AMMENDMENTS AS NOTED 02.19 AND REISSUED TO COUNCIL С 04.19 AMMENDMENTS AS NOTED AND REISSUED TO COUNCIL

ALE	PROJECT NO.	DRAWING NO.	DRAWING
200 @ A3	1816A	A-0102	GROUND FLOOR PLAN

91-93 MCINTOSH ROAD NARRAWEENA NSW 2099

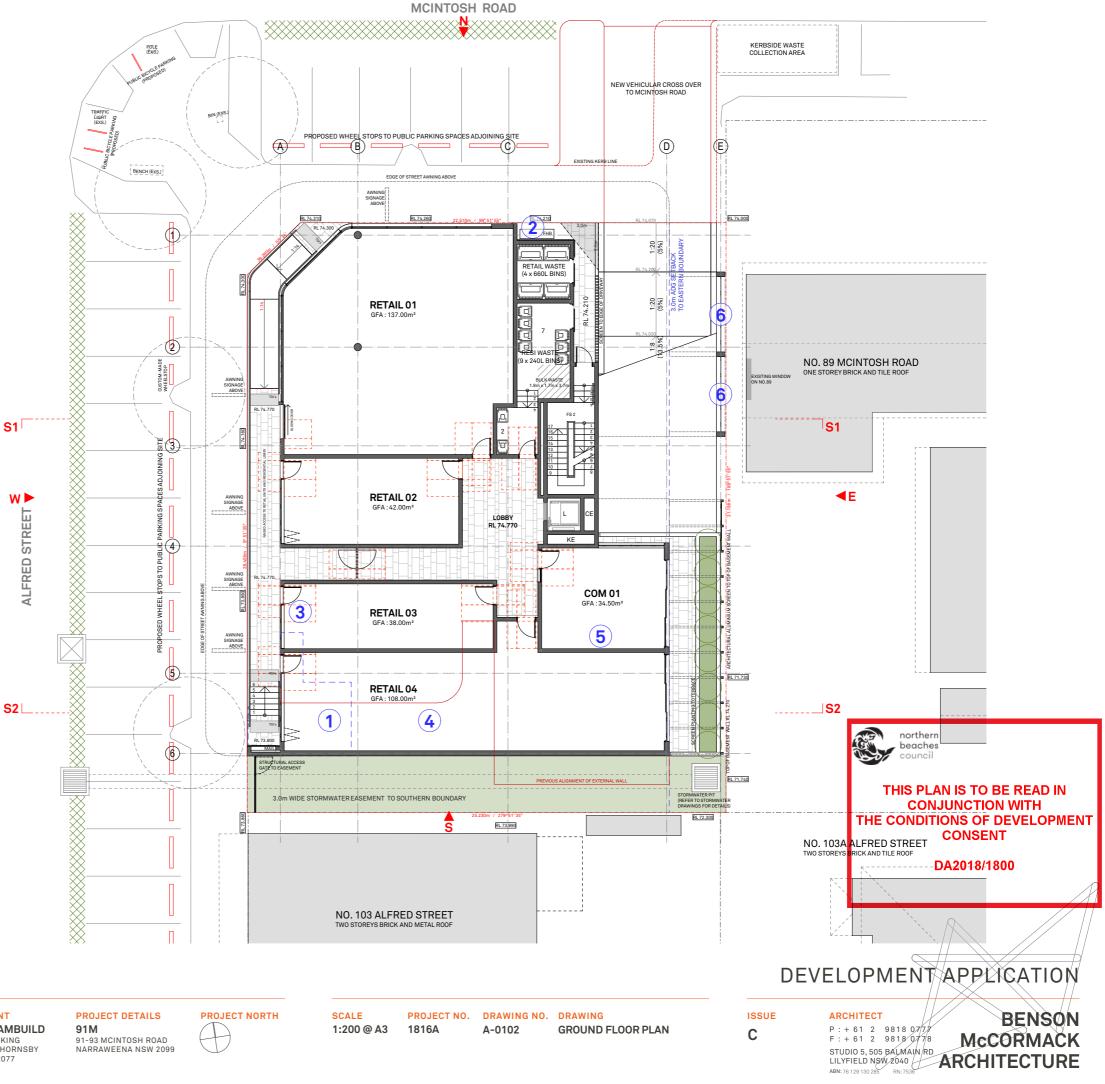
- 1. PREVIOUS LOCATION OF FIRE HYDRANT BOOSTER & FIRE STAIR 1
- 2. PROPOSED LOCATION OF FIRE HYDRANT BOOSTER
- 3. AMENDMENTS TO AREA AND FRONT FACADE OF RETAIL 03
- 4. PROPOSED AREA OF RETAIL 04
- 5. PROPOSED AREA OF COM1 AND REMOVAL OF COM 2
- 6. PROPOSED POLYCARBONATE ACOUSTIC BARRIER AT 2.2M (HEIGHT) x 4M (LENGTH) x 10MM (THICK) TO ACOUSTIC CONSULTANT SPECIFICATION

ALE .	PROJECT NO.	DRAWING NO.	DRAWING
00 @ A3	1816A	A-0103	1ST FLOOR PLAN

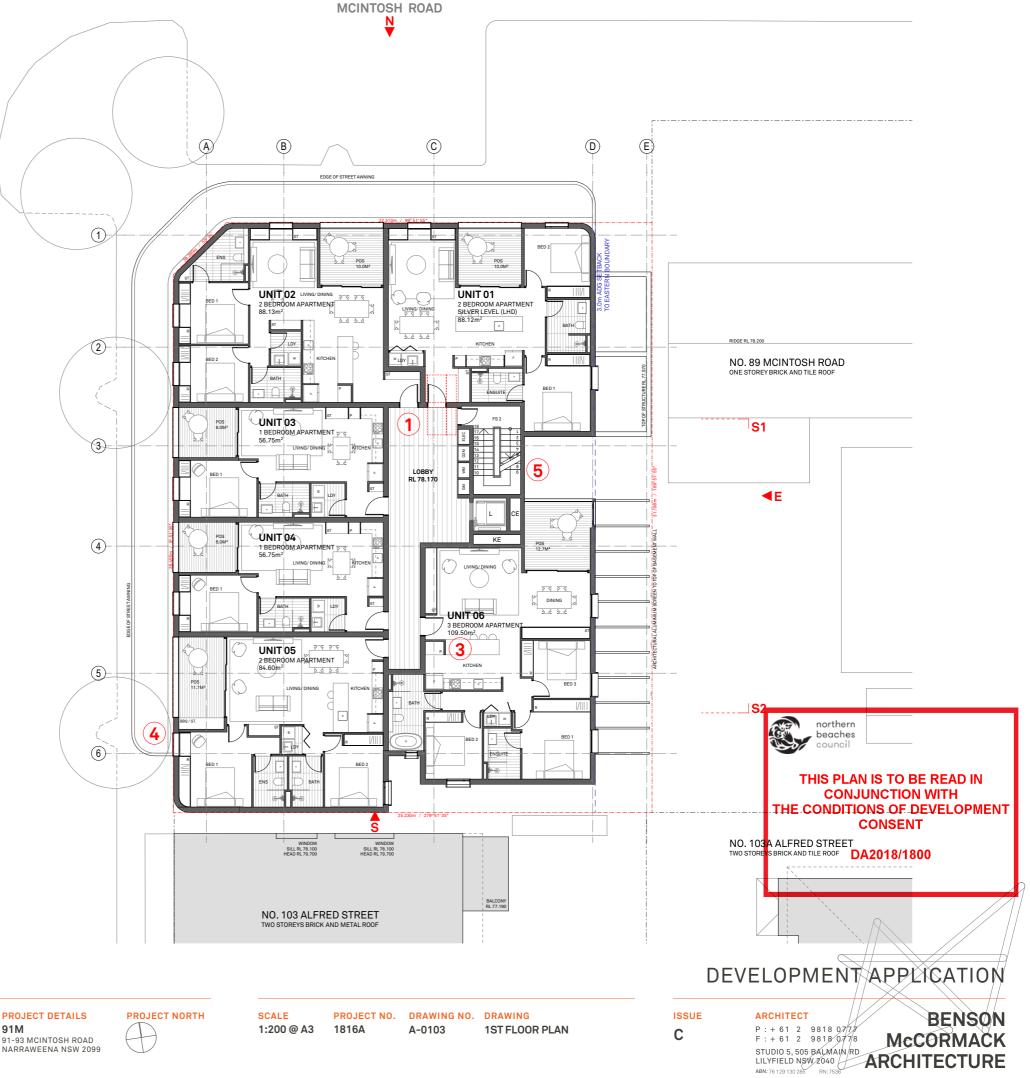
- 1. CIRCULATION DOOR CLEARANCES AS SHOWN TO UNIT 01 THIS HAS RESULTED IN MINOR CHANGES TO THE ENTRY OF UNITS 01 AND 02
- 2. UNIT BALCONY SIZES ADDED AND AMENDED AS SHOWN FROM PREVIOUS ISSUE
- 3. MINOR INCREASE IN SIZE TO UNIT 06 DUE TO EXTERNAL WALL CHANGES AT LEVEL 2
- 4. REDUCTION IN LENGTH OF STREET AWNING TO ALFRED ST TO ACCOMODATE 3M WDIE EASEMENT TO SOUTHERN BOUNDARY
- 5. MINOR AMENDMENTS TO CORE CONFIGURATION

SCALE	PROJECT NO.	DRAWING NO.	DRAWING
1:200 @ A3	1816A	A-0105	ROOF PLAN

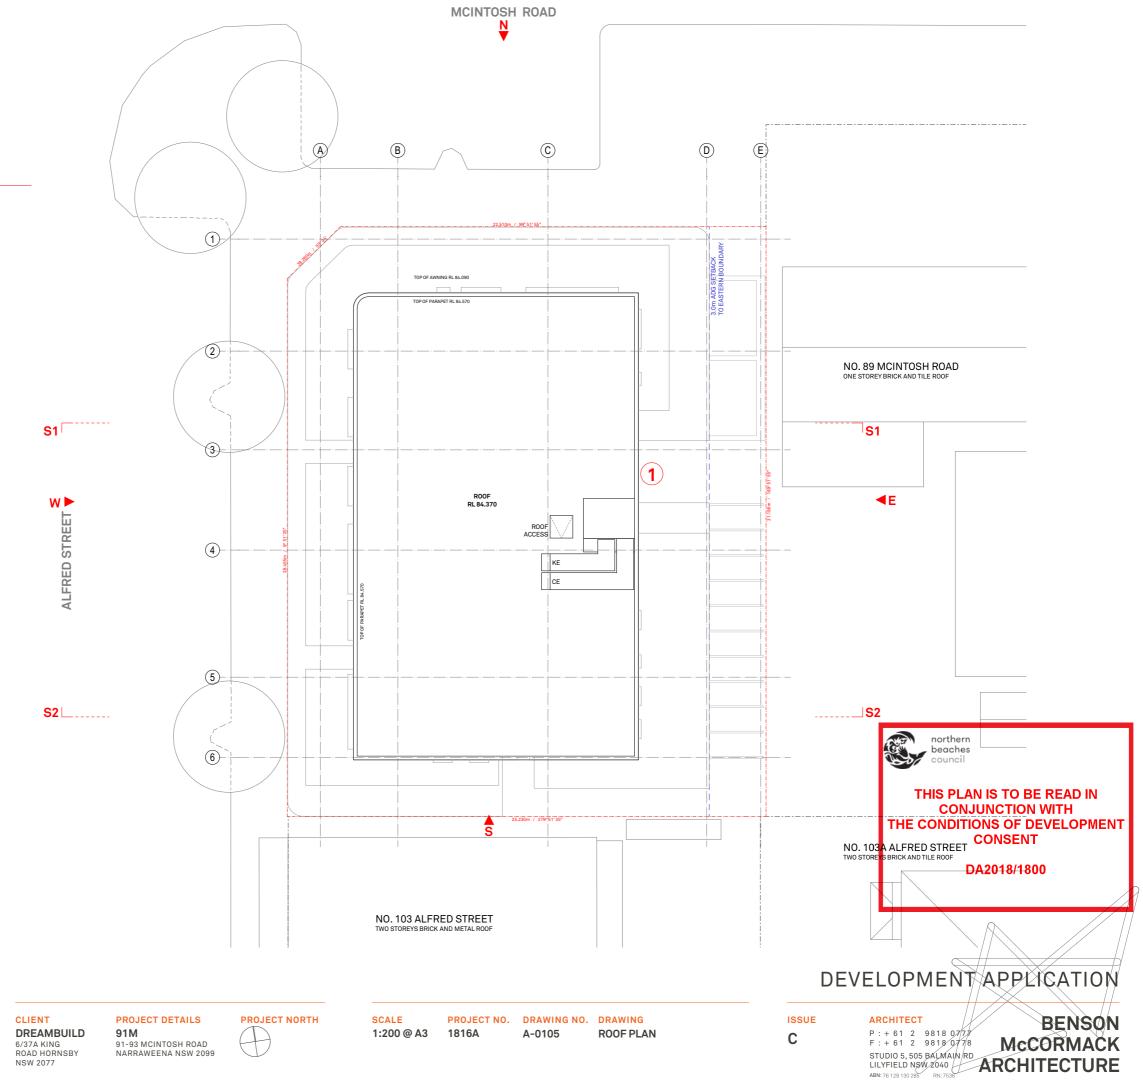
1. MINOR AMENDMENTS TO CORE CONFIGURATION AND ROOFTOP PLANT

SCALE PROJECT NO. DRAWING NO. DRAWING 1:100 @ A3 1816A A-0201 MCINTOSH RD ELEVATION

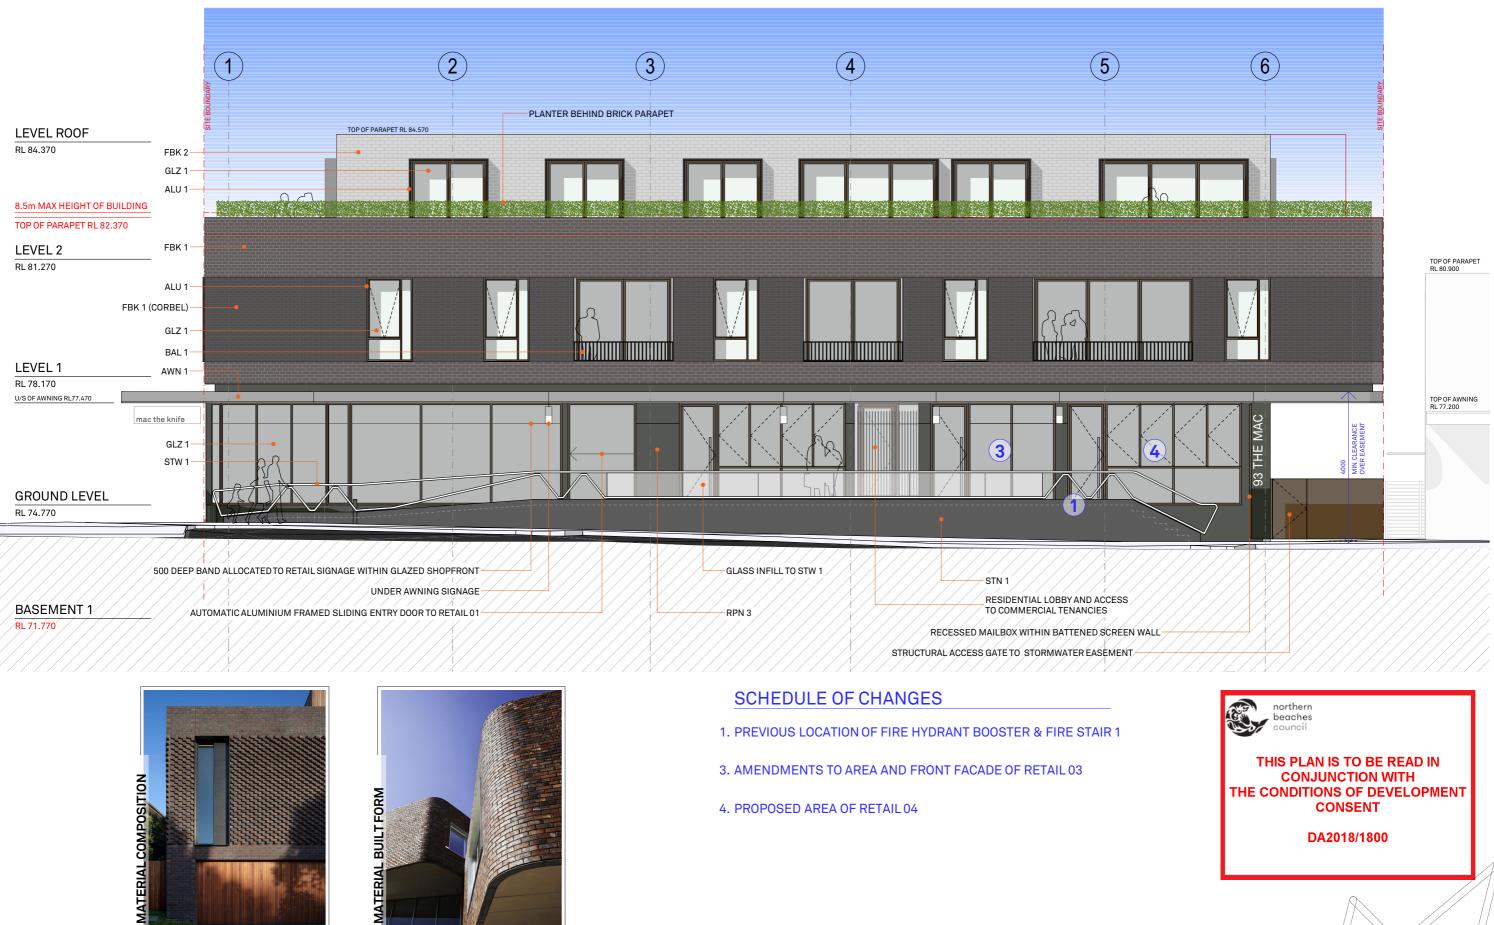
2. PROPOSED LOCATION OF FIRE HYDRANT BOOSTER

SCALE PROJECT NO. DRAWING NO. DRAWING 1:100 @ A3 1816A A-0203 EAST ELEVATION

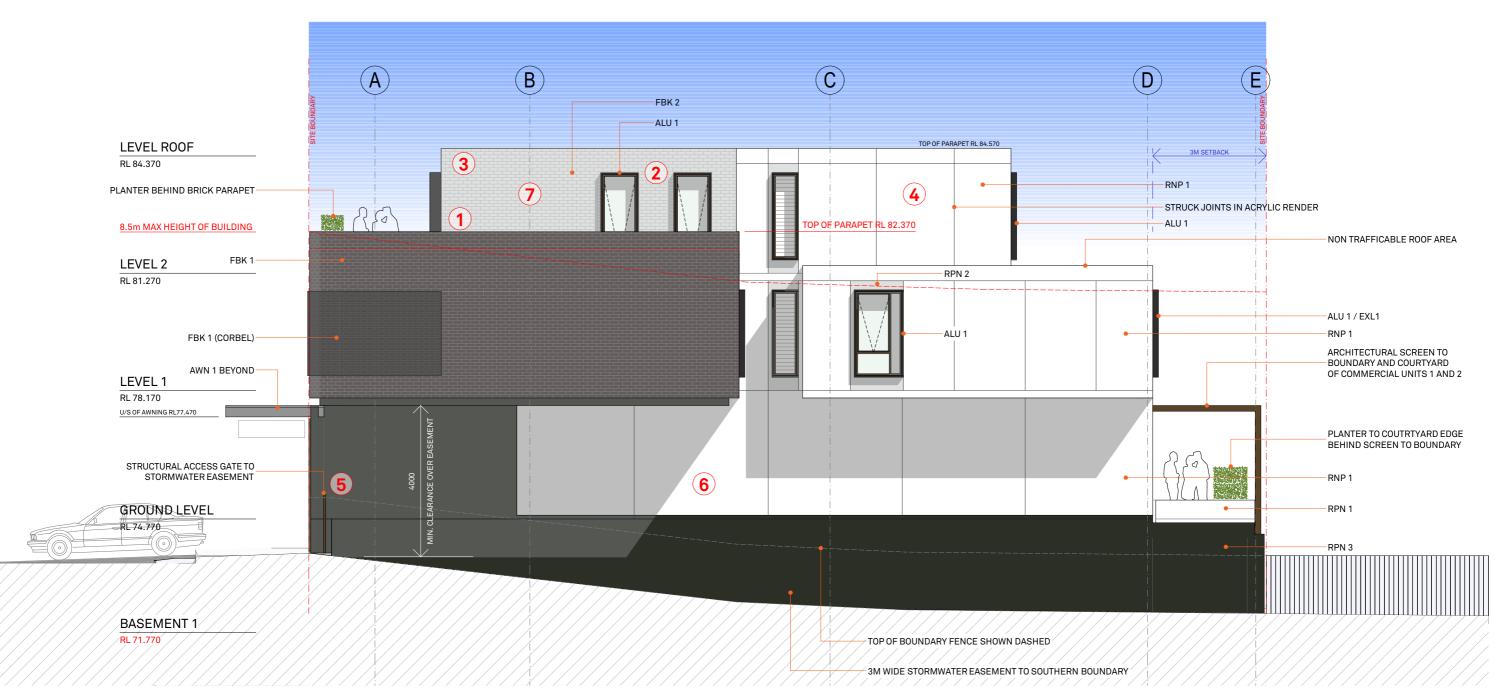
- 2. PROPOSED LOCATION OF FIRE HYDRANT BOOSTER
- 4. PROPOSED AREA OF RETAIL 04
- 5. PROPOSED AREA OF COM1 AND REMOVAL OF COM 2
- 6. PROPOSED POLYCARBONATE ACOUSTIC BARRIER AT 2.2M (HEIGHT) x 4M (LENGTH) x 10MM (THICK) TO ACOUSTIC CONSULTANT SPECIFICATION

SCALE	PROJECT NO.	DRAWING NO.	DRAWING	
1:100 @ A3	1816A	A-0204	SOUTH ELEVATION

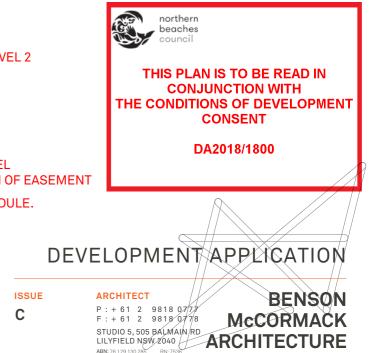
- 1. BRICK PARAPET RAISED TO 1100MM ABOVE TERRACE AT LEVEL 2
- 2. EXTERNAL ALUMINIUM SURROUNDS ADDED TO OPENINGS AT LEVEL 2
- **3. CONTINIOUS AWNING TO LEVEL 2 REMOVED**
- 4.2 X COLOURED ACRYLIC RENDER ADDED. RENDER TO HAVE STRUCK JOINTS AS INDICATED.
- 5. STRUCTURAL ACCESS GATE TO STORMWATER EASEMENT ADDED
- 6. ELEVATIONAL CHANGES TO SOUTHERN FACADE AT GROUND LEVEL TO ACCOMDATE REVISED PLANNING DUE TO INCREASE IN WIDTH OF EASEMENT
- 7. FACEBRICK ADDED TO LEVEL 2. REFER REVISED FINISHES SCHEDULE.
